06-0156

**Re: GE-Pittsfield/Housatonic River Site
Former Oxbow Areas A and C (GECD410)
Addendum to Pre-Design Investigation Work Plan**

ADDENDUM TO PRE-DESIGN INVESTIGATION WORK PLAN FOR FORMER OXBOW AREAS A AND C REMOVAL ACTION
GENERAL ELECTRIC COMPANY - PITTSFIELD, MASSACHUSETTS

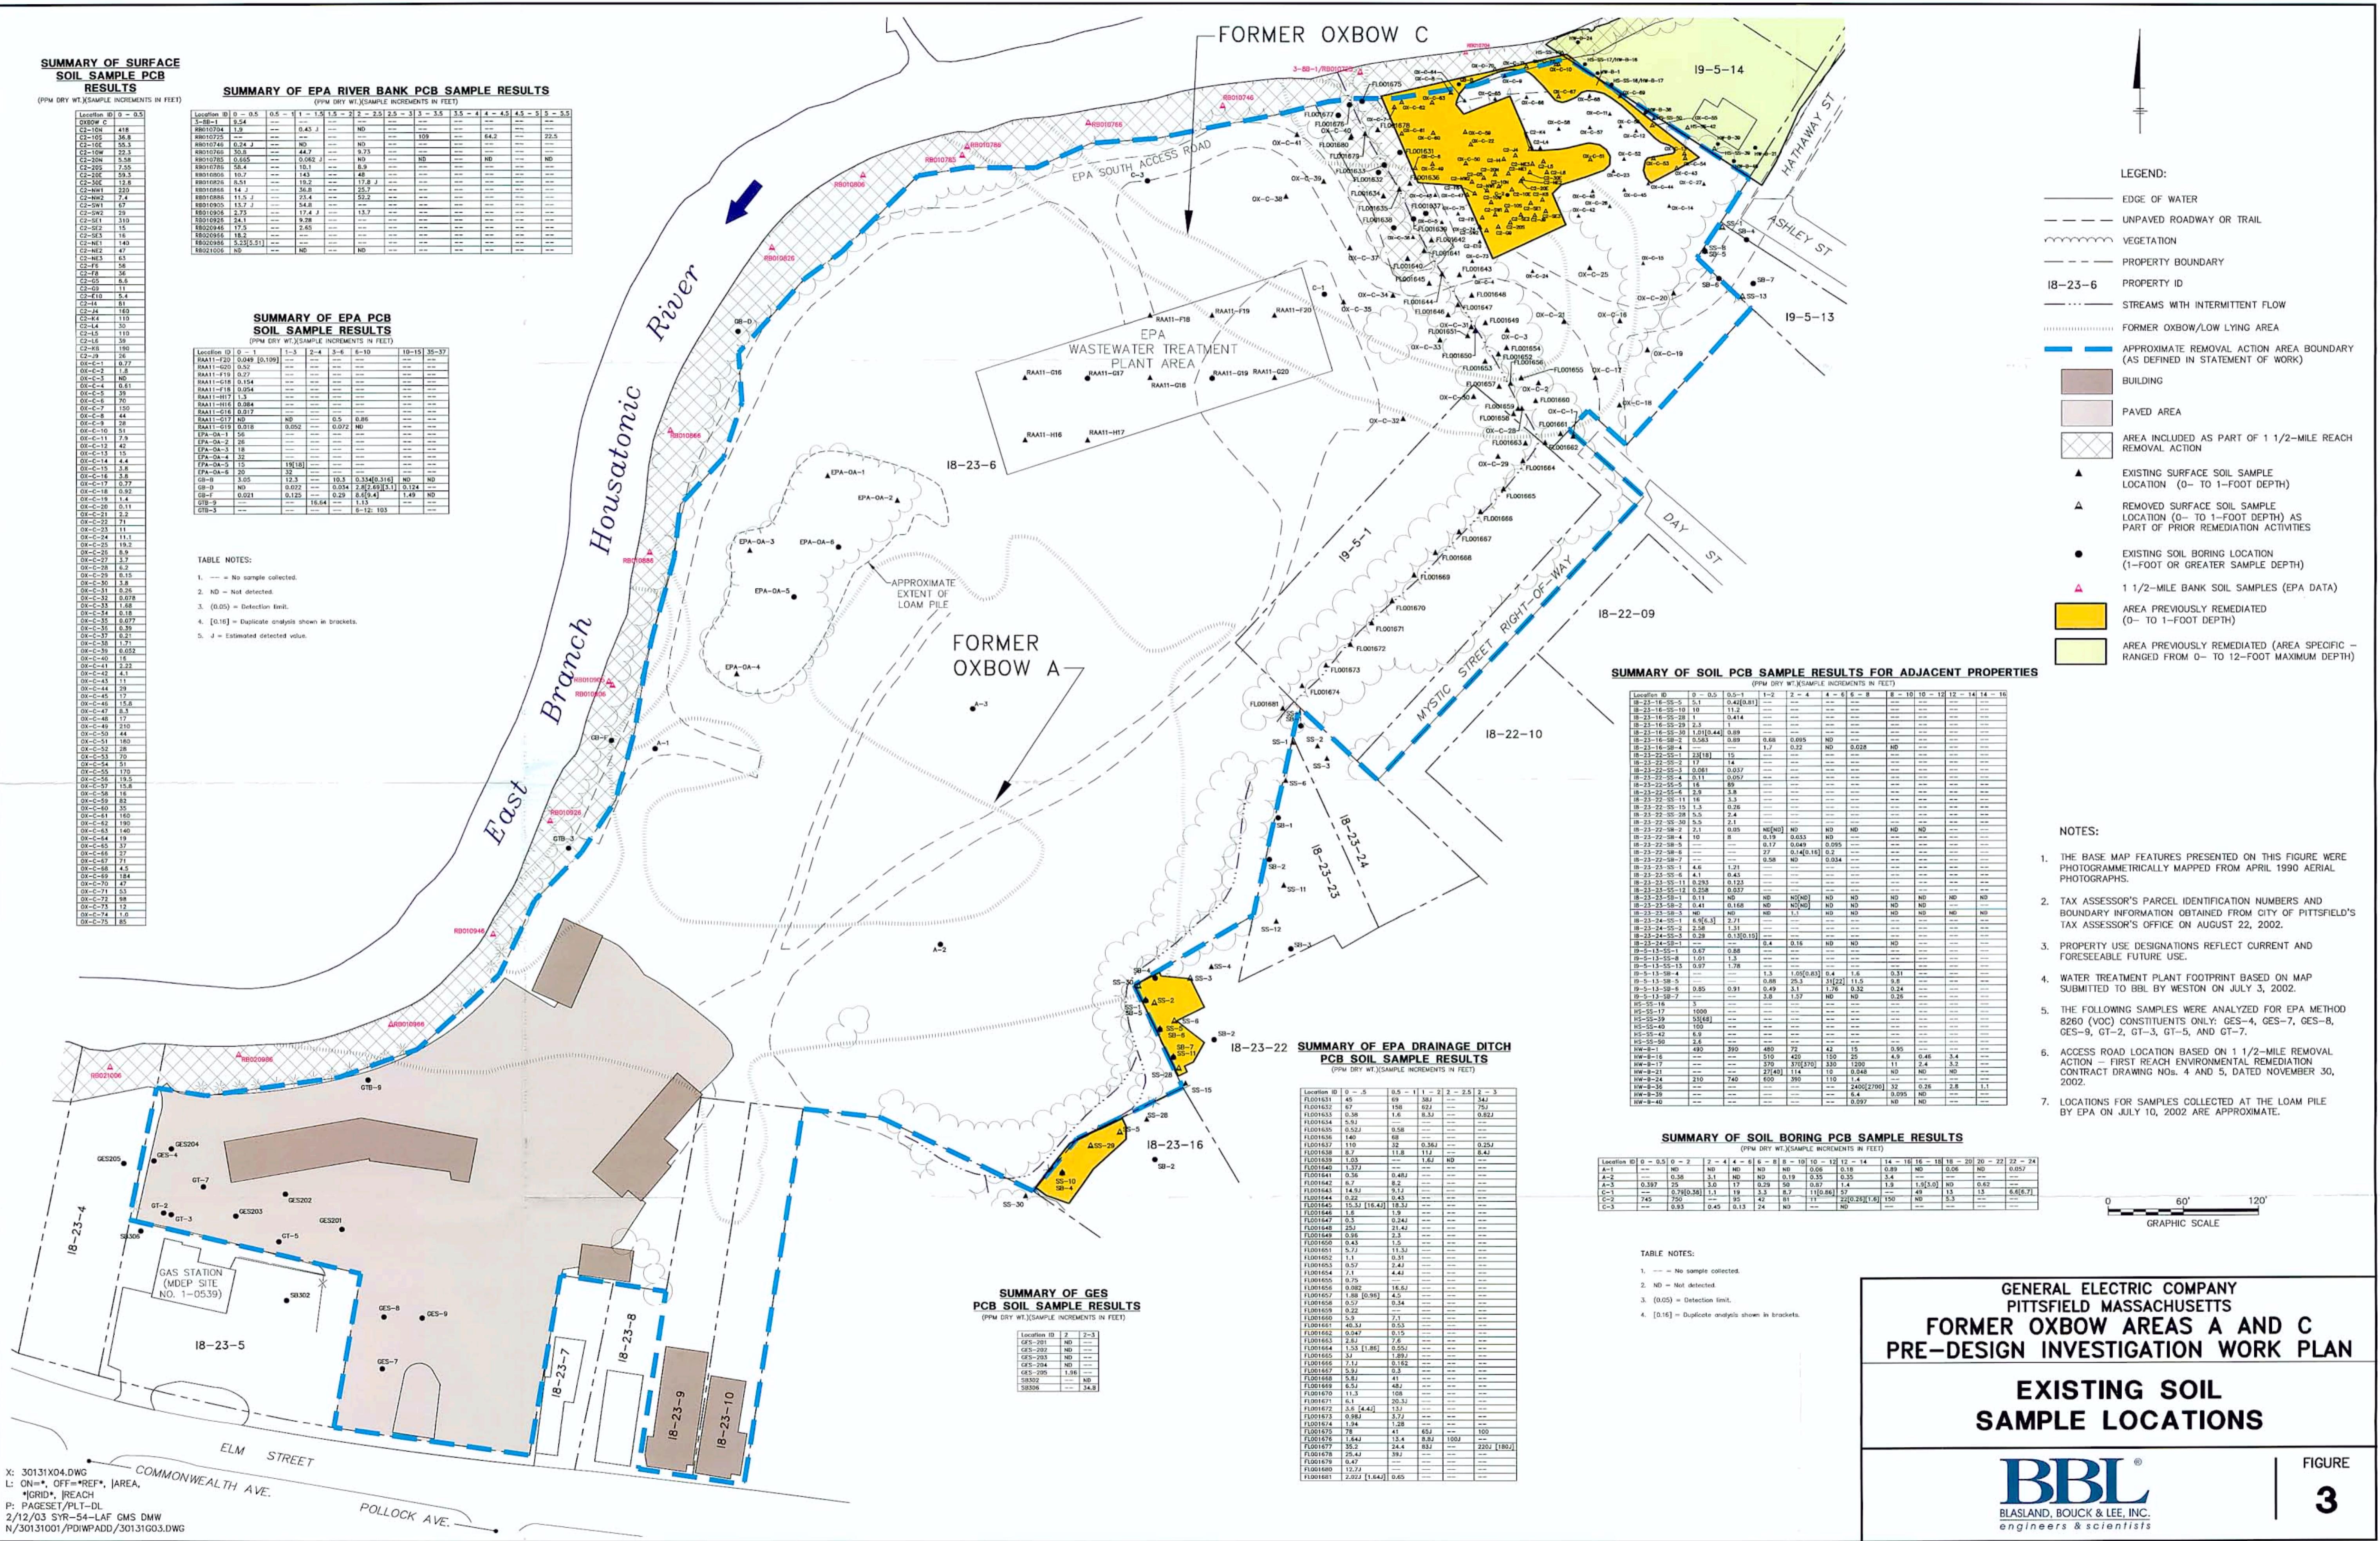
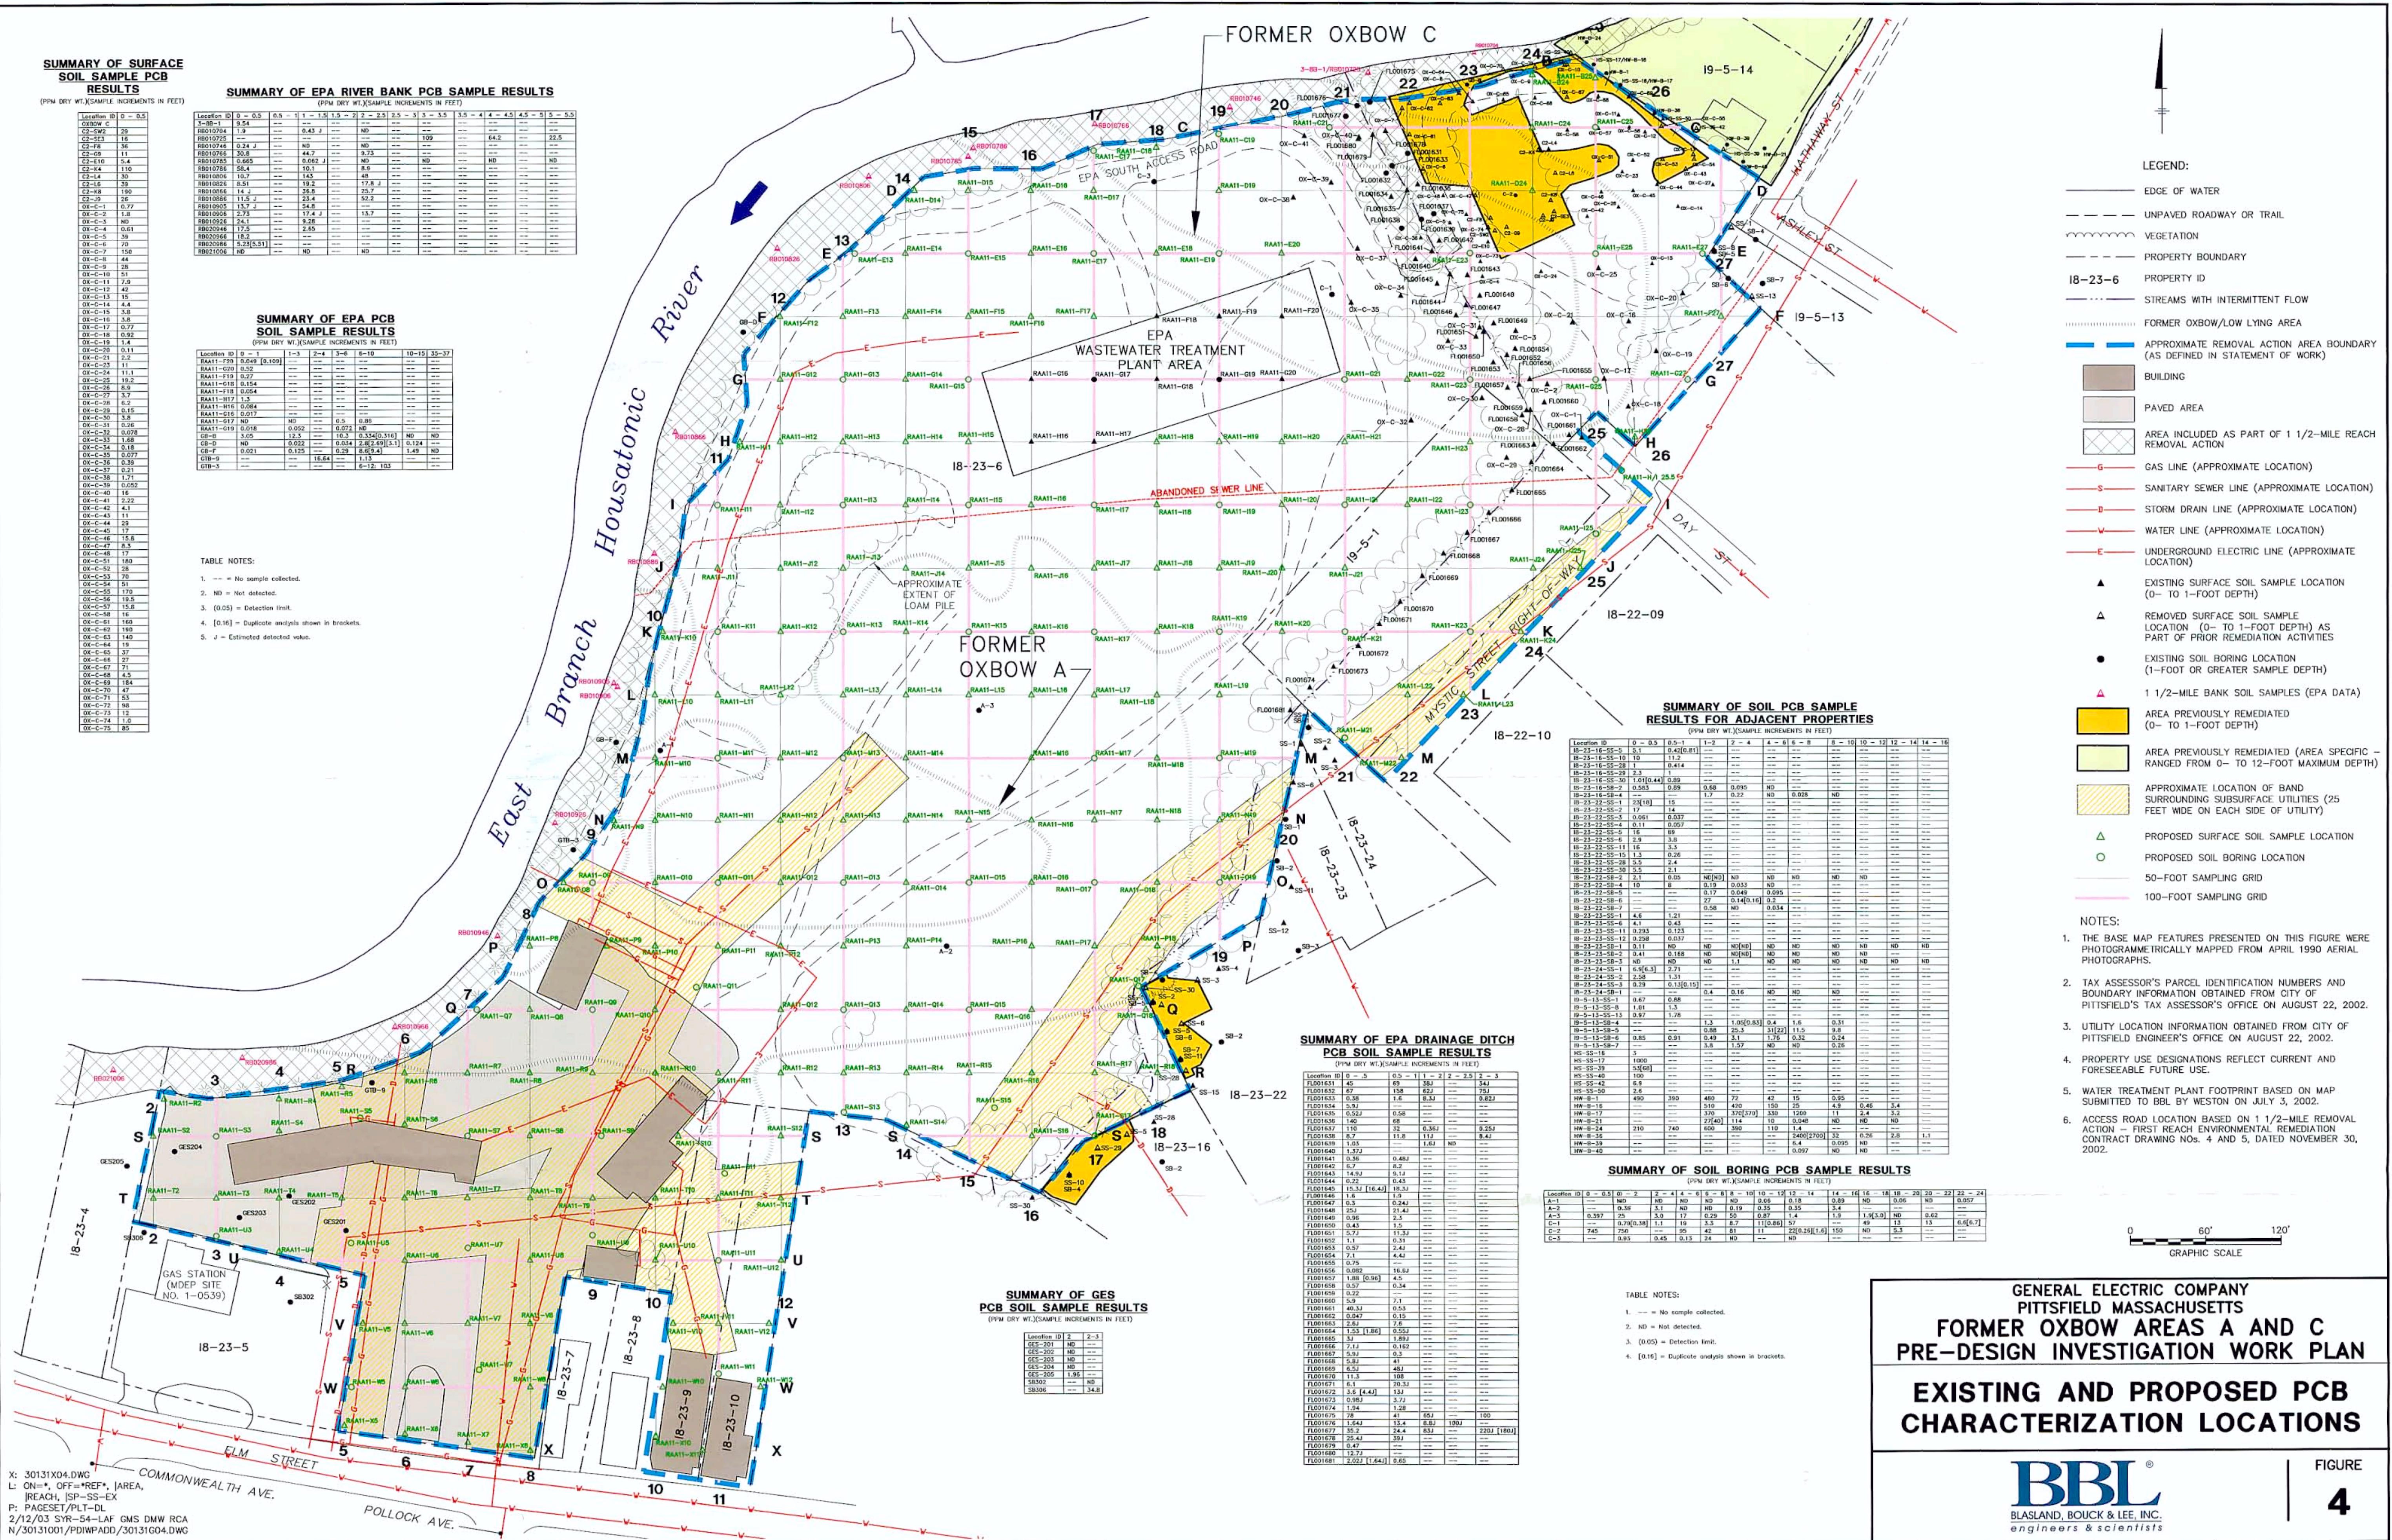
In addition, PCB soil data recently reported in a document entitled *Audit Follow-Up Completion Status Report, Former Mobil Service Station No. 01-ECQ, 83-89 Elm Street, Pittsfield, Massachusetts* (GES, 2002), dated December 31, 2002 and received by GE on January 15, 2003, were reviewed. Seven of the sampling locations associated with the Elm Street Mobil site investigation (GES201 through GES205, SB302, and SB306) are situated within or in close proximity to this RAA. These locations are shown on Figure 3 and the associated PCB samples are included in the listing in Table 1, while the analytical PCB data are presented in Attachment B. The available documentation for these samples, which consists of a standard laboratory reporting form (Form I), reveals no reason not to use these data for RD/RA evaluation purposes. Five of these samples, GES-201 through GES-205, are reported as having been collected at 2 feet. GE will verify that these samples were in fact 0- to 2-foot soil samples (as opposed to being grab samples). If so, the PCB results from those samples will be used as supplemental data in RD/RA evaluations, as indicated in Table 1. Likewise, the PCB results from samples SB302 and SB306, which were collected at a depth of 2-3 feet, will be used as supplemental data in the RD/RA evaluations, as also indicated in Table 1. All seven of these sample locations have also been added to Figure 4.

2. As required in Condition No. 2 of EPA's conditional approval letter, GE has extended the sampling grid established for Parcel I9-5-1 southeast to the centerline of the right-of-way (ROW) for the proposed extension of Mystic Street, as shown on Figure 4. The locations of the proposed PCB samples in this ROW are shown on Figure 4 and included in Tables 3 and 4, while an additional sample for other Appendix IX+3 constituents has been added in this ROW (at location RAA11-K24), as shown on Figure 5 and Table 4. In addition, as required by EPA's conditional approval letter, GE has added a boring at the mid point of the Day Street extension (paper street) directly northeast of the Mystic Street ROW (location H/I 25.5), as shown on Figure 4 and Tables 3 and 4.

4. Condition No. 4 of EPA's conditional approval letter requires that GE use the ground surface beneath the current loam pile near former Oxbow A as the basis for establishing soil sampling depths in this area. GE will use the original grade at base of the loam pile as the zero-reference depth from which to determine the sampling depths proceeding downward. Table 1 has been revised to identify the loam pile samples collected by Weston for EPA as eliminated, and these

locations have been removed from Figure 4. However, although these samples have been eliminated from use for grid characterization or RD/RA evaluation purposes, they are shown as existing sample locations on Figure 3 for informational purposes.

6. In response to Condition No. 6 of EPA's conditional approval letter, GE has further reviewed utility drawings obtained from the City of Pittsfield. From this review, it was determined that the utility locations depicted on Figure 4 of the PDI Work Plan (including the potable water main, gas line, sanitary sewer line, and stormwater pipeline located within the RAA) are generally accurate. These locations are also shown on the enclosed Figure 4, along with the 50-foot-wide utility bands along them. This review also determined that the depth of the sanitary sewer located in the southwest portion of this RAA is greater than 15 feet below grade at certain locations (but not more than 20.5 feet below grade). As a result, for this utility line, GE has added the proposed sampling depths shown below.

Note: The location for sample RAA11-U5 will be moved approximately 15 feet north of the location shown in the PDI Work Plan to provide characterization sampling at the maximum depth of the sanitary sewer line in this southwest area of the RAA (Figure 4).

EPA's conditional approval letter also requires that the location of soil boring RAA11-Q11 be moved approximately 30 feet to the west-northwest to provide additional data for the utility band in this area. That change has been made, as shown on Figure 4. In addition, GE has moved the location of proposed soil boring RAA11-I25 approximately 20 feet south of the respective grid node to provide additional data for the utility band within the Mystic Street ROW. Also, the location of proposed soil boring RAA11-W7 has been moved approximately 15 feet northeast of the respective grid node to provide additional data for the utility band in this area.

11. As required in Condition No. 11 of EPA's conditional approval letter, GE has moved the location for soil boring RAA11-Q17 approximately 35 feet northeast of the grid node to the corner of Parcels I8-23-6 and I8-23-22, as shown on Figure 4. In addition, the location of boring RAA11-S15 has been moved approximately 30 feet northeast of the grid node (as also shown on Figure 4) to maintain coverage for characterization of the utility band for the sanitary sewer line located near the southern boundary of the RAA.
